REMARKS

This Amendment is responsive to the Office Action dated February 27, 2004. Applicant has amended claims 1, 4 and 6-8, and added new claims 9-17. Claims 1-17 are pending upon entry of this amendment.

FIG. 2a

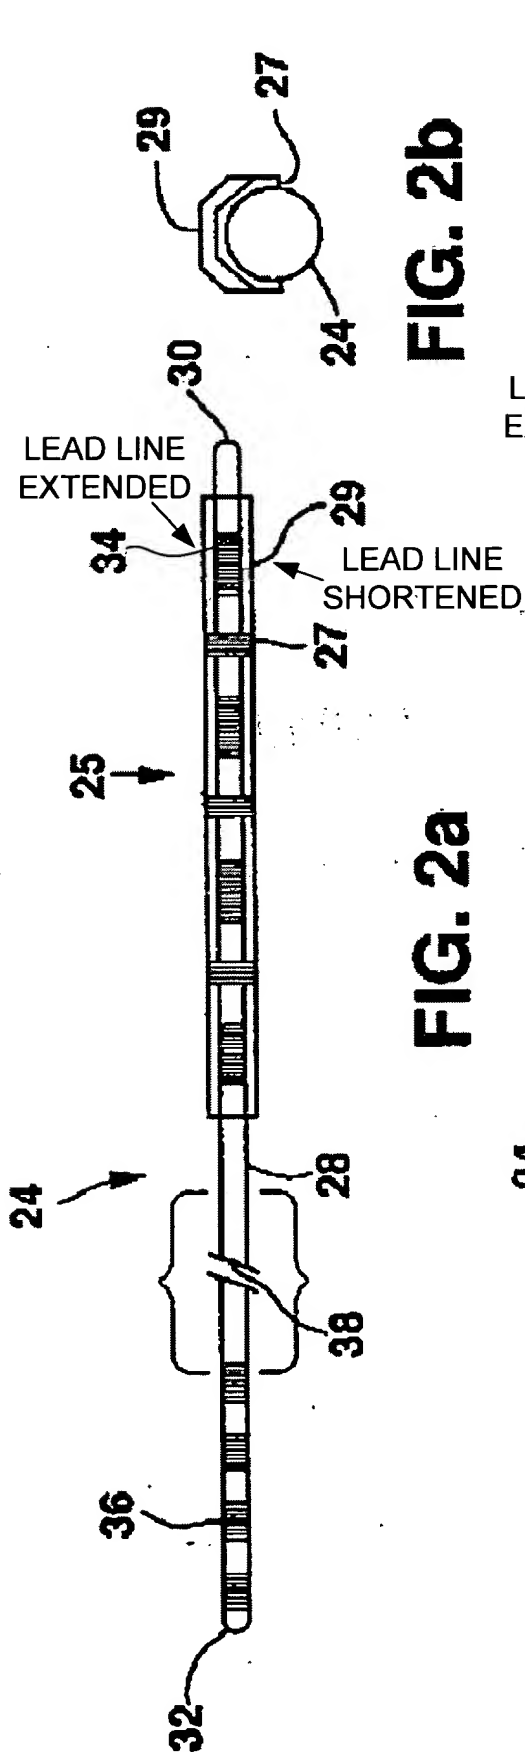
As a preliminary matter, the Examiner objected to the drawings under 37 C.F.R. § 1.83(a) “because they fail to clearly show the exact structure of the shield and attachment detail.” The Examiner further stated that, in particular, the shield has a higher elevation than the attachment detail in all of the cross-sectional drawings, but appears to have the same height in the adjacent drawings. With this Amendment, Applicant has submitted corrections to FIGS. 2a, 3a, 4a, 5a, and 6a, which should overcome the Examiner’s objection.
